Planning Commission Vote Report

Petition: **P.Z. 11-2017 Steve W Wallace Automotive & Trailer II, LLC (Ordinance Amendment):**
A request to amend Ordinance 2841 to amend the development conditions in a “C-8” Planned Commercial District, for a 2.93 acre tract of land located southeast of the intersection of Chesterfield Airport Road and Long Road (17U140441, 17U140450, 17U140461 & 17U140472).

Re: P.Z.11-2017 Steve W Wallace (Automotive and Trailer II, LLC) – Responses to issues/comments from the Public Hearing on August 28, 2014 at City Hall.

**NORTHWEST AUTOMOTIVE
EXHIBIT 10/4/17**

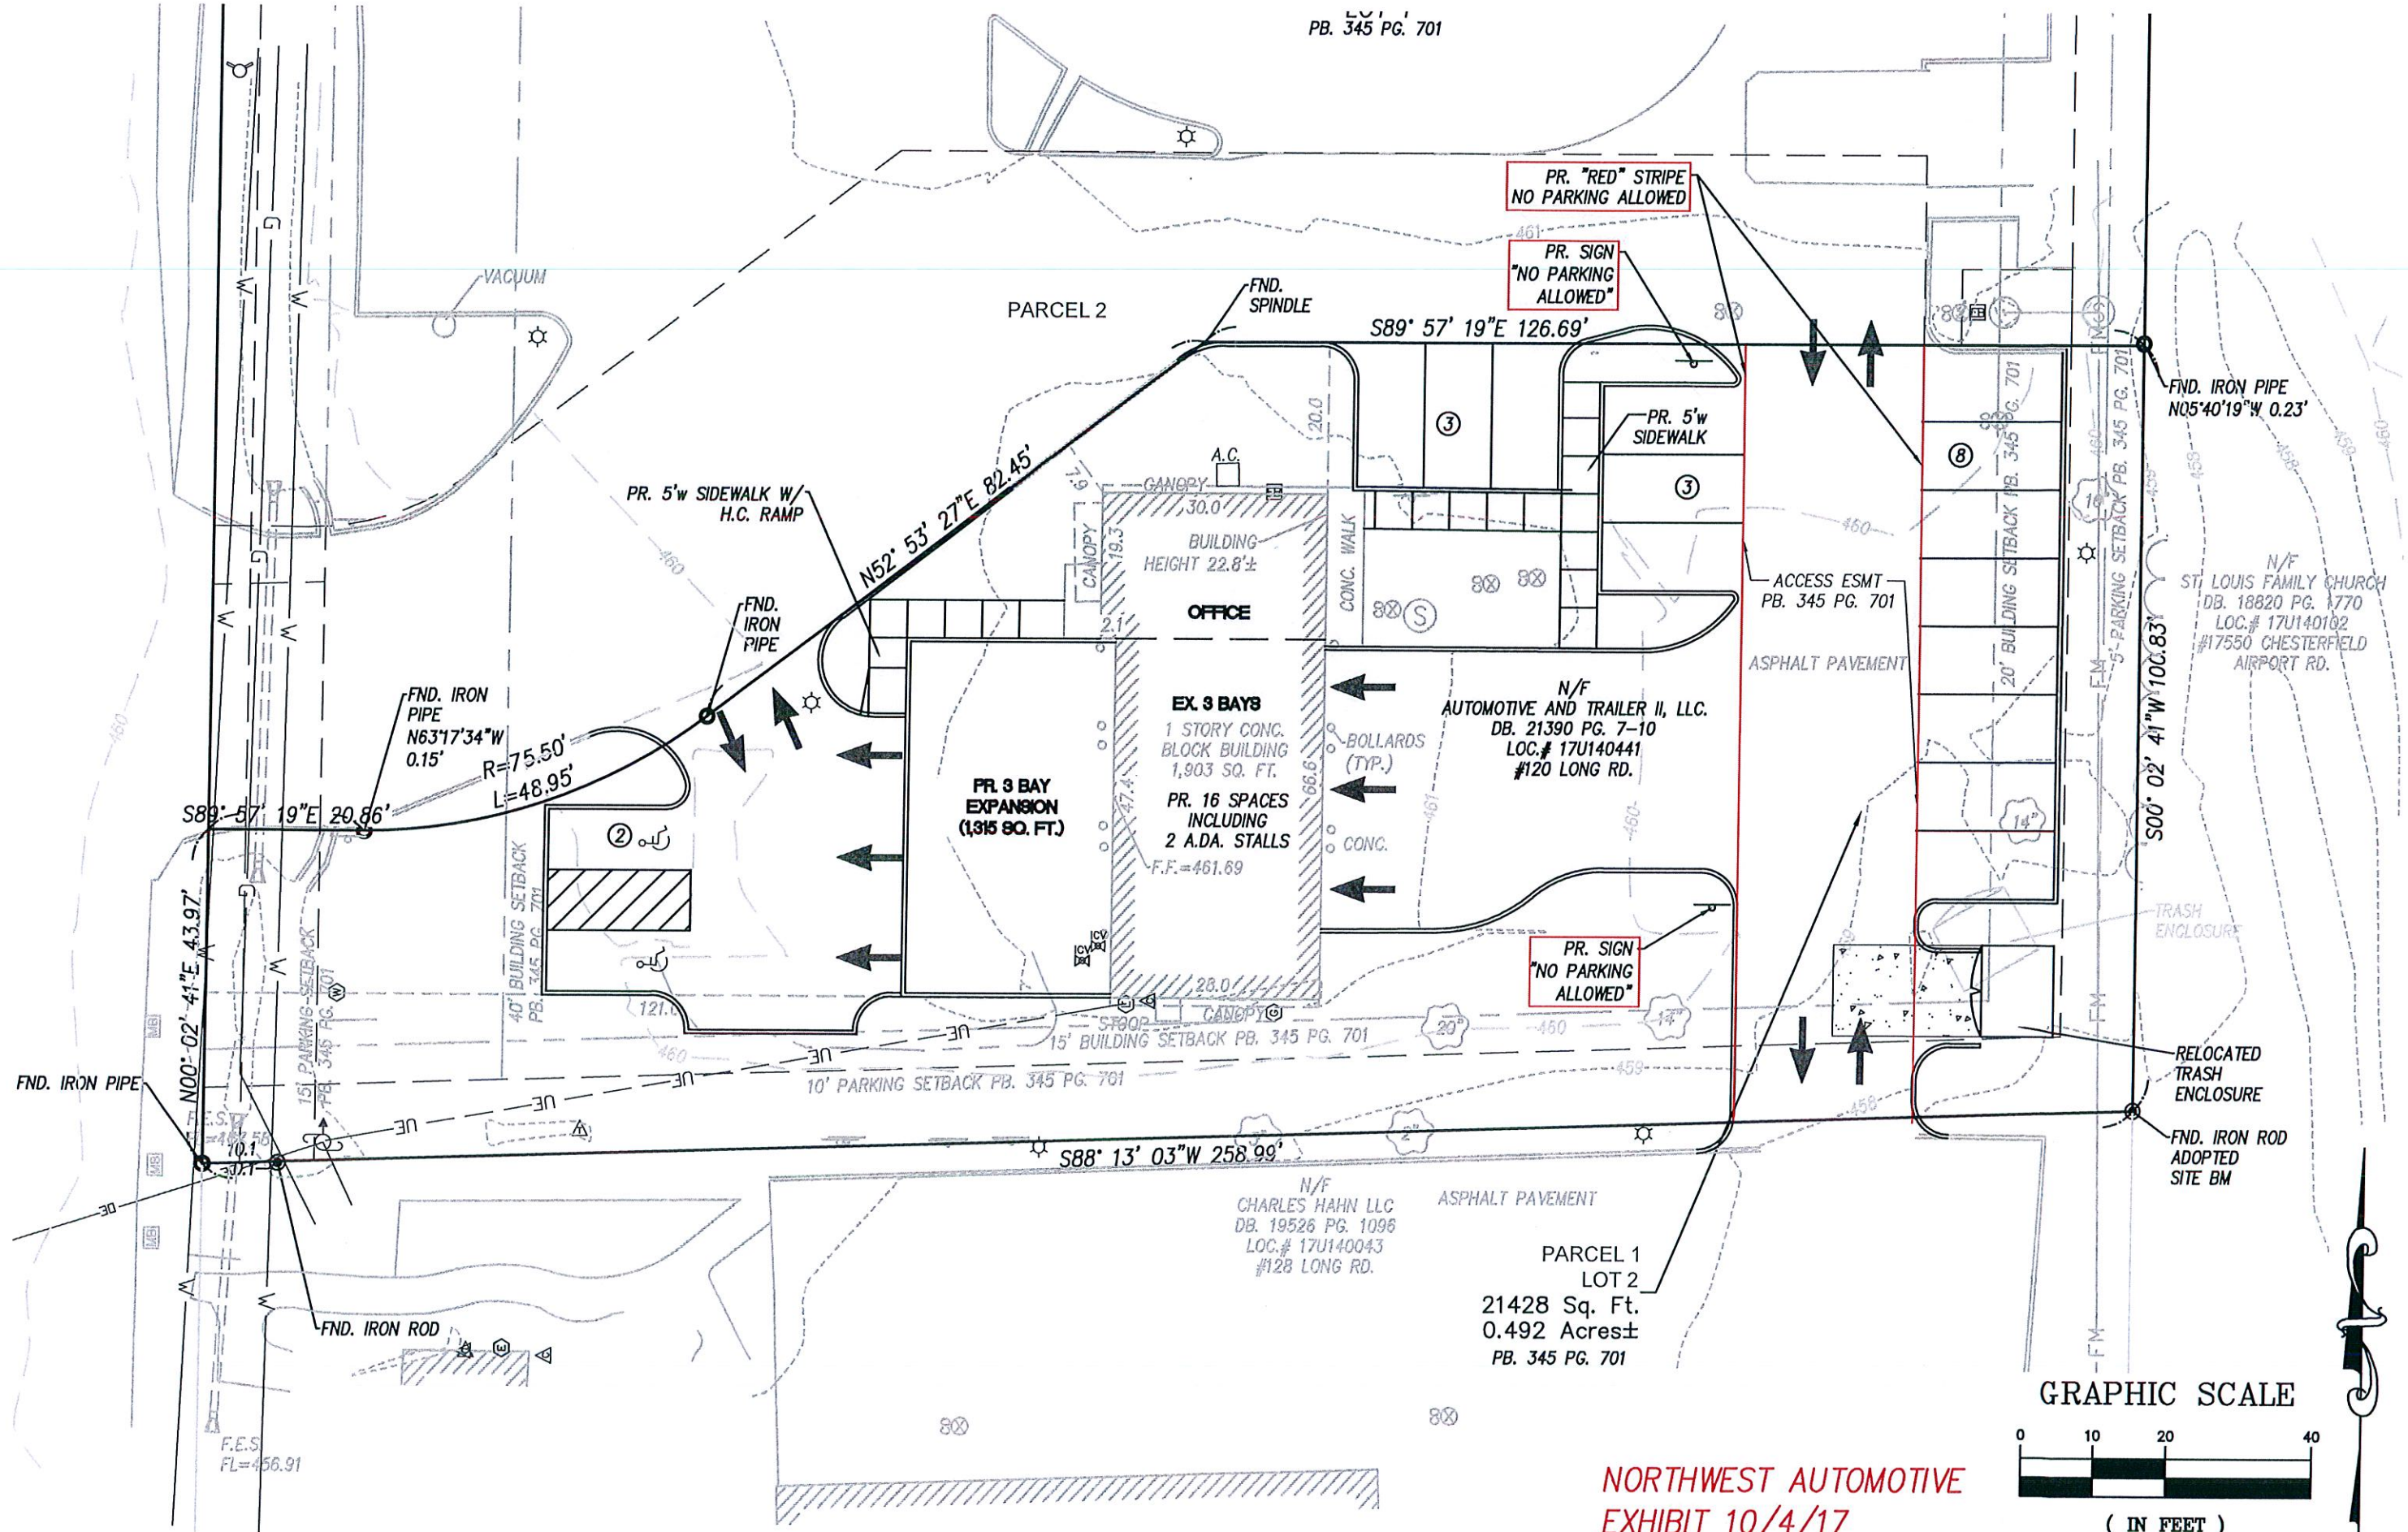
First, regarding the existing Cross Access Easement, Book 345, Page 701 located near the eastern portion of the site. This drive and easement area will be striped "red" and signed "no parking or blocking" (see attached drawing). This will ensure no incidental obstructions occur and block the neighbor's access.

PR. "RED" STRIPE
NO PARKING ALLOWED

PR. SIGN
"NO PARKING
ALLOWED"

PRELIMINARY SITE PLAN FOR TEXT AMENDMENT TO SECTION I OF ORD. NO. 2841

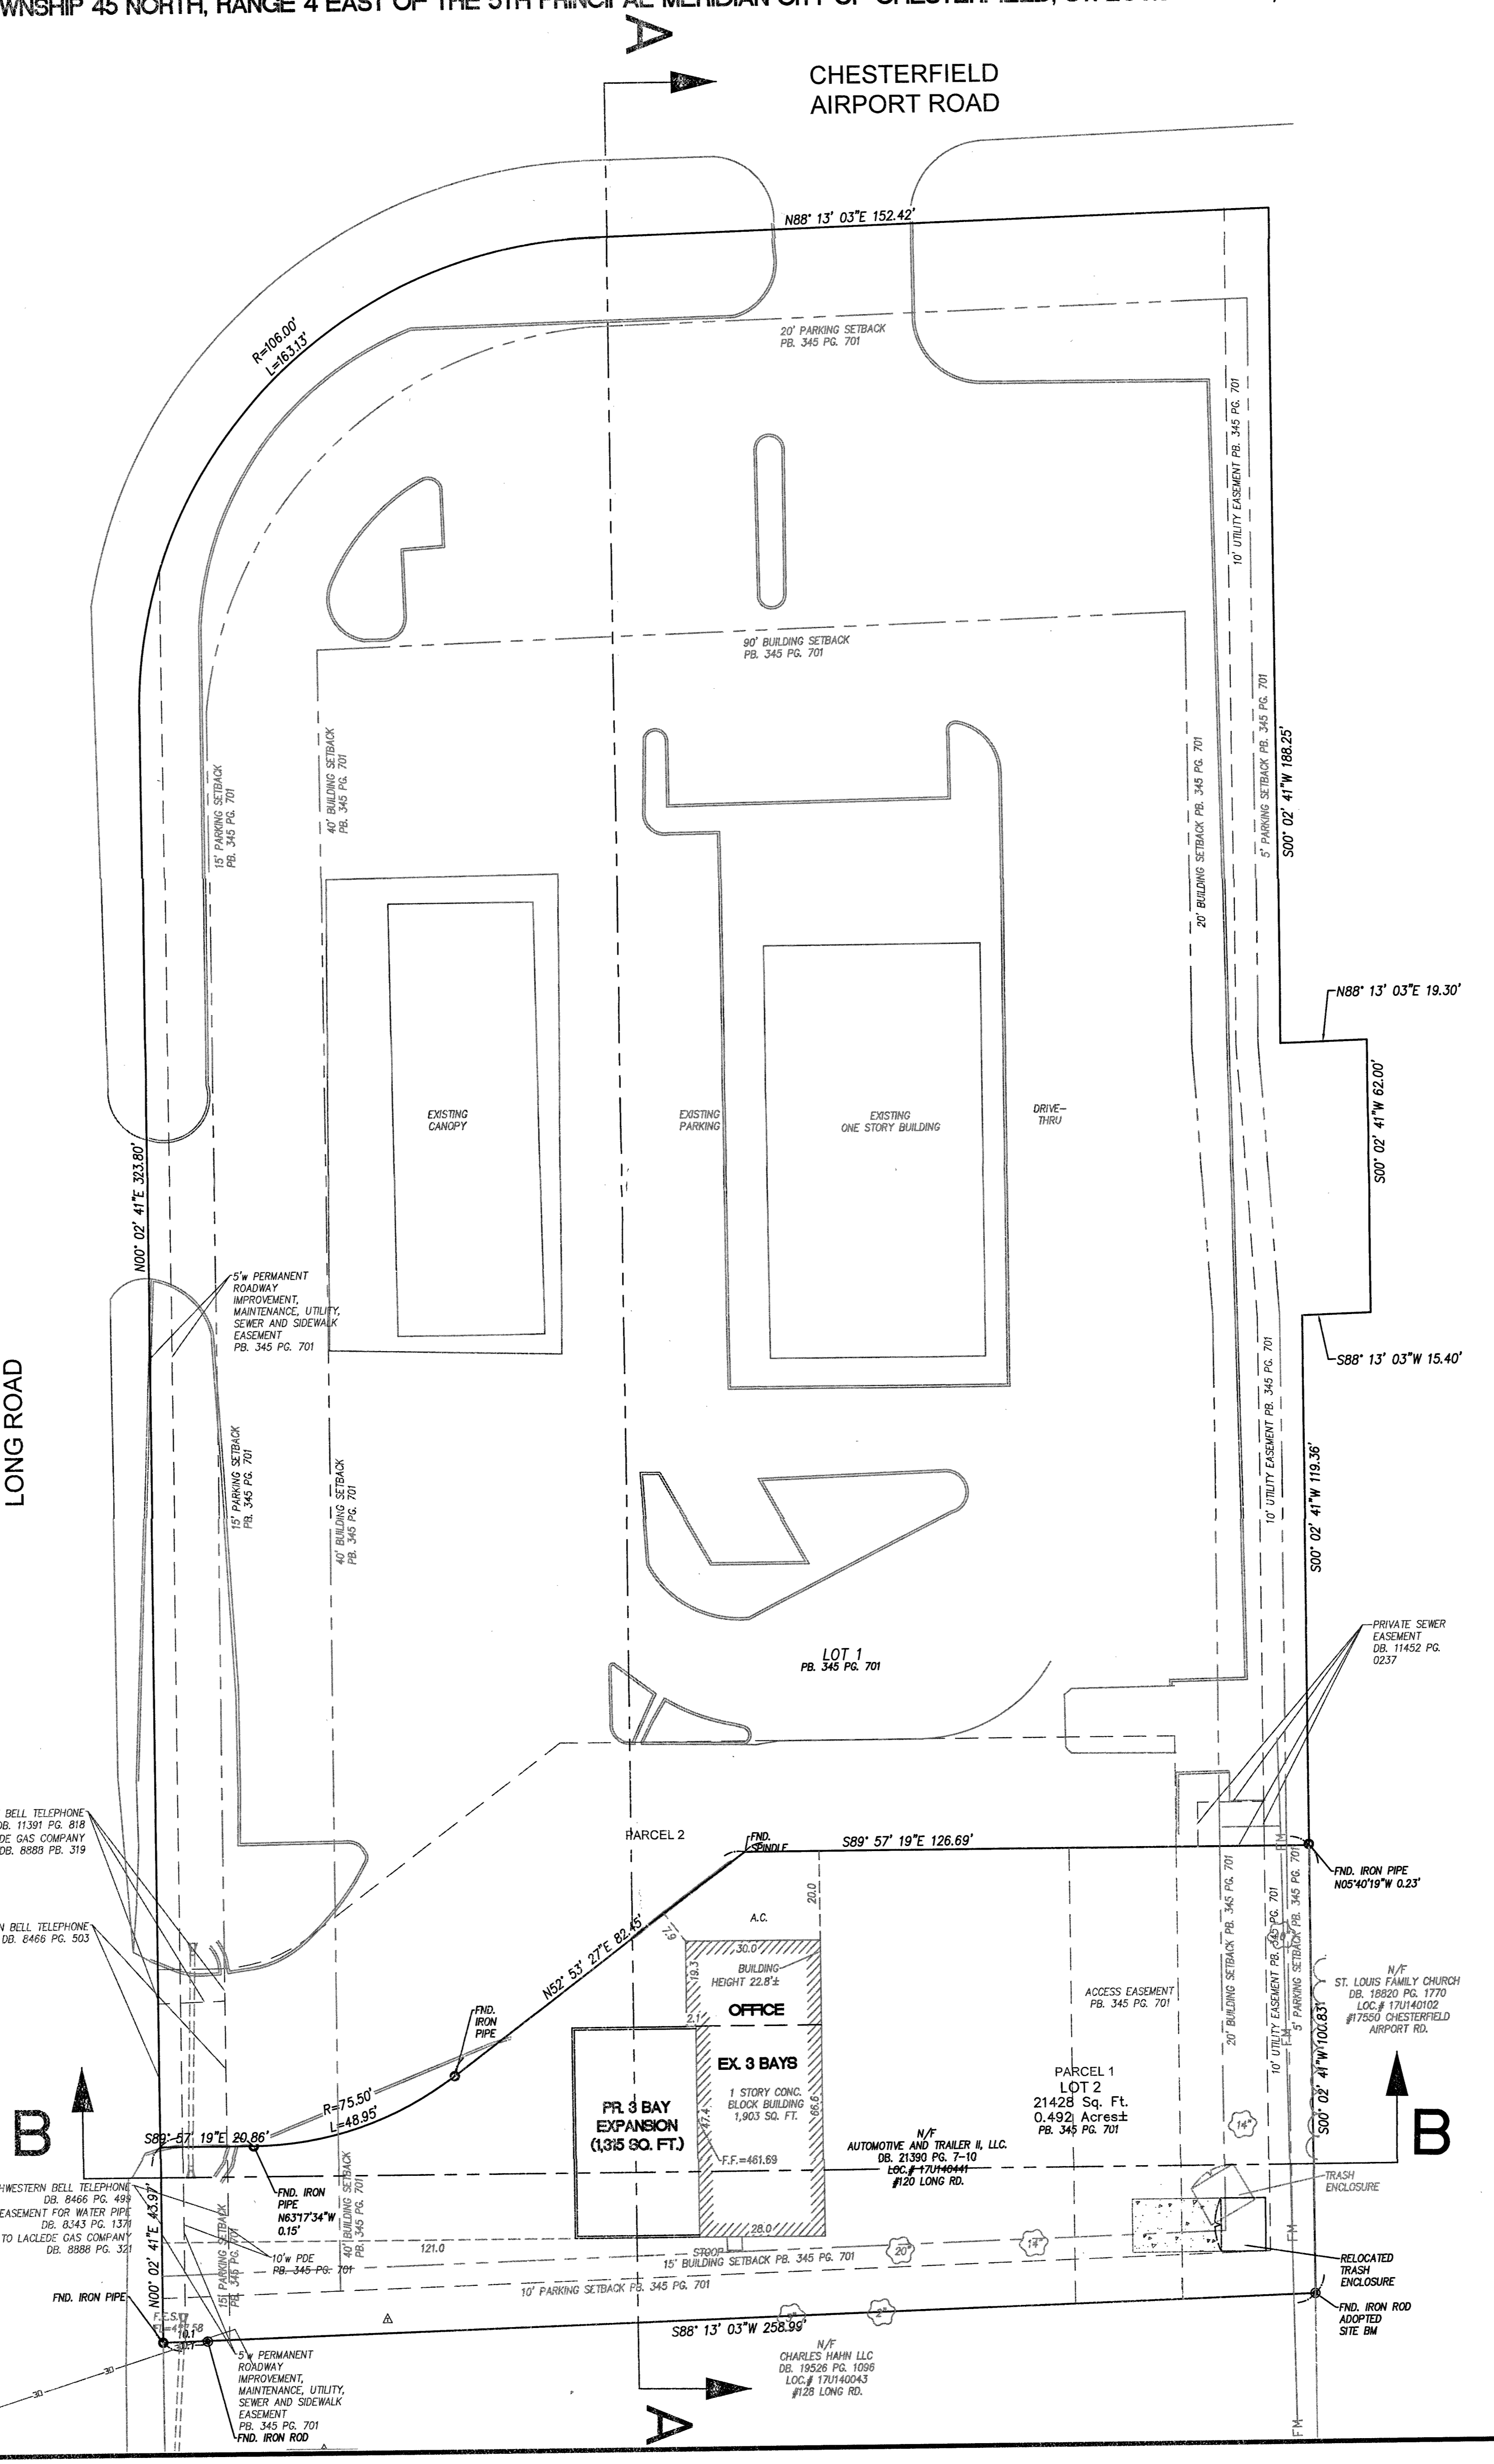
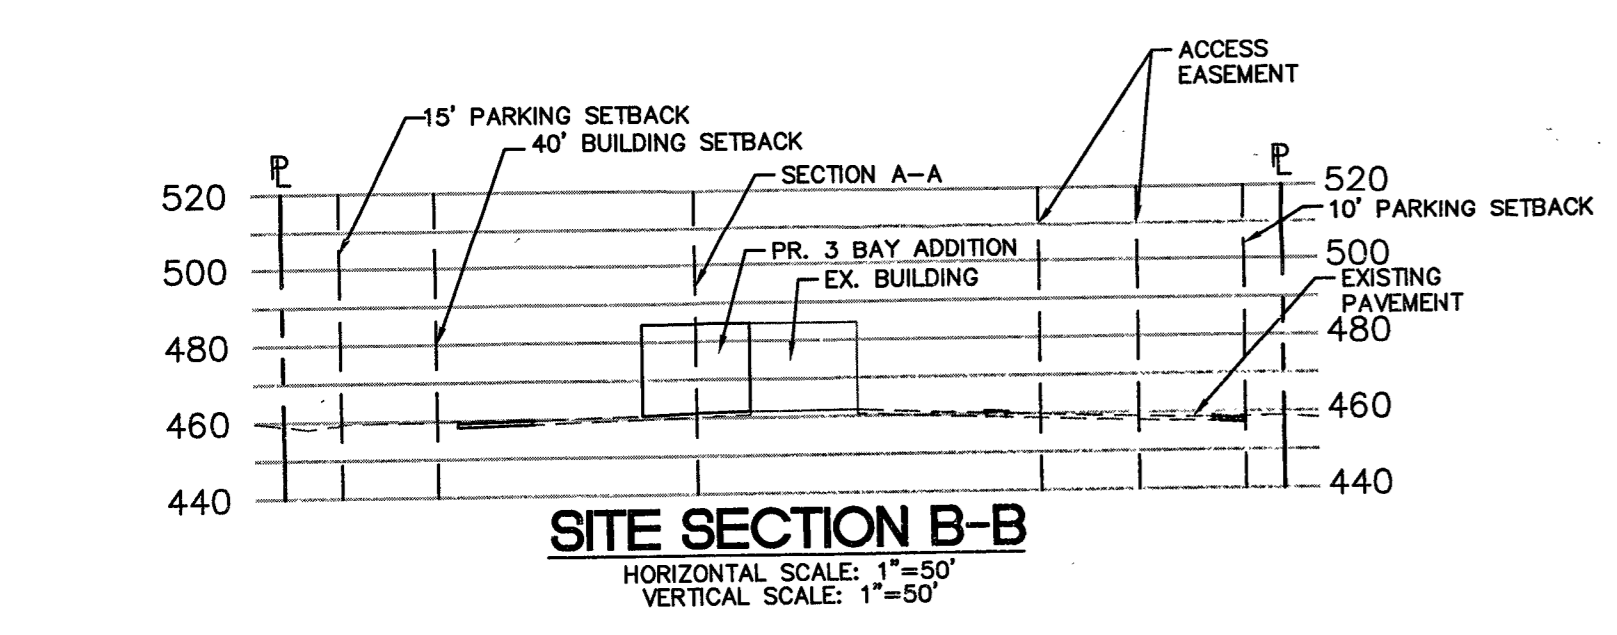
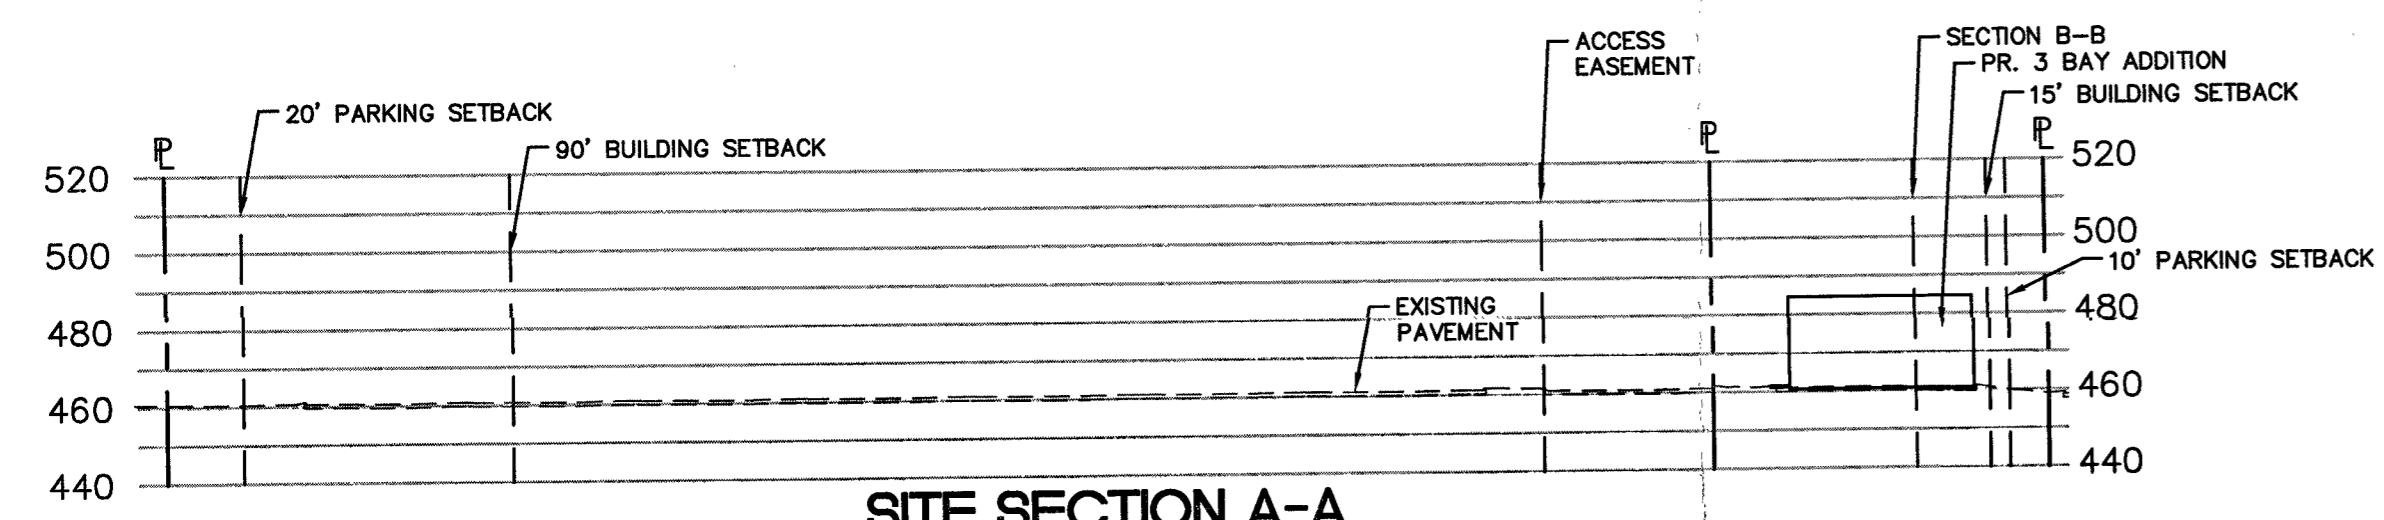
Comment 1. Open Space: 27% is already below the typical 30% required of developments today. Re-evaluate the need to reduce the open space.

Comment 3. Depict and label the parking and structure setbacks on all sides of the entire development. be advised that staff will recommend that the structure setbacks remain the same, and that the trash enclosure be an exception, there we ask that you remove the proposed 10' building setback line.

Comment 4. Label all easements throughout the development, including the record plat book and page number.

Comment 5. Label all property lines' bearing and distance for the entire development.

Comment 6. Remove Note 3 of General Notes regarding the number of parking stalls on site.

Response: The proposed preliminary site plan has been revised, and we will maintain an open space of 27.00%.

Response: Setbacks have been added and the proposed 10' building setback line has been removed.

Response: Please see Preliminary Site Plan.

Response: Please see Preliminary Site Plan.

Response: Note has been removed.
